TECHNICAL SERVICE BULLETIN

2.7L/3.0L EcoBoost - Oil Pan Leaking

24-2345

This bulletin supersedes 23-2338. Reason for update: revised Service Procedure, update Part List

Figure 1

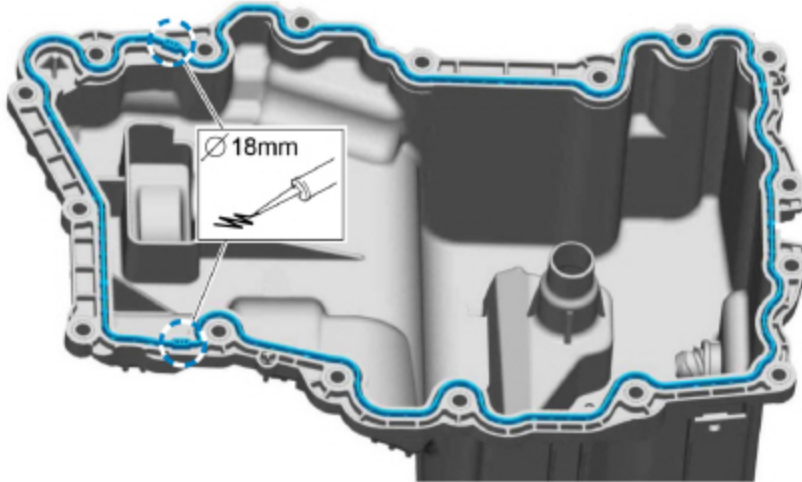
4. Verify the correct orientation of the new press in place gasket and install the new oil pan. Refer to the [WSM](#), Section 303-01, Removal and Installation > Oil Pan.

(1). Apply an 18 mm bead of Motorcraft® High Performance Engine RTV Silicone at the T-joints, where the ladder frame meets the front cover (Figure 1)

NOTE: The new oil pan does not require the use of Motorcraft® High Performance Engine RTV Silicone in any other location.
